Access Compliance Report

Public Rights-of-Way

(Curb Ramps)

Intersection ID: N/A	Main Street: DALLAS_BAY_RD	Cross Street: HAMILTON_BRIDGE_RD	Location: SE
ADA ID: FBF36B57ECA2	Ramp Type: Perp	Initial Pass/Fail: Fail	Overall Compliance: No
Severity Score: 12.5			
Codes/Mitigation Info/Possible Solution		Field Measurements/Component Compliance

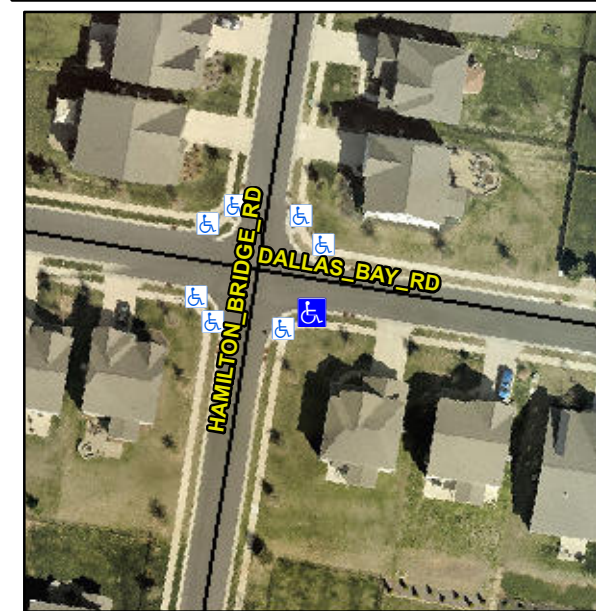
Not Found, R304.2.2

Compliance	Description	Data	Compliance	Description	Data
N/A	Ramp Length (in)	47.0	No	Ramp Slope (%)	8.5
Yes	Ramp Width (in)	49.0	Yes	Ramp XSlope (%)	2.0
N/A	Flare Type LT	N/A	N/A	Flare Type RT	N/A
N/A	Flare Slope LT (%)	N/A	N/A	Flare Slope RT (%)	N/A
N/A	Flare Traversable LT?	N/A	N/A	Flare Traversable RT?	N/A
N/A	Landing Length (in)	N/A	N/A	DWS Provided?	N/A
N/A	Landing Width (in)	N/A	N/A	DWS Contrast?	N/A
N/A	Landing Slope (%)	N/A	N/A	DWS Length (in)	N/A
N/A	Landing X Slope (%)	N/A	N/A	DWS Full Width?	N/A
N/A	Landing Curb? (Y/N)	N/A	N/A	DWS Offset (in)	N/A
N/A	Shared Landing?	N/A			
N/A	Gutter Ponding?	N/A	N/A	Gutter Slope (%)	N/A
N/A	Gutter Lip Ht (in)	1.0	N/A	Gutter X Slope (%)	N/A
N/A	Painted X Walk1?	No	N/A	Painted X Walk2?	N/A
	X Walk 1 Direction	To NE		X Walk 2 Direction	N/A
N/A	X Walk 1 Width (in)	N/A	N/A	X Walk 2 Width (in)	N/A
	X Walk 1 Slope (%)	2.2		X Walk 2 Slope (%)	N/A
	X Walk 1 X Slope (%)	0.6		X Walk 2 X Slope (%)	N/A

Remove & Replace Entire Ramp.
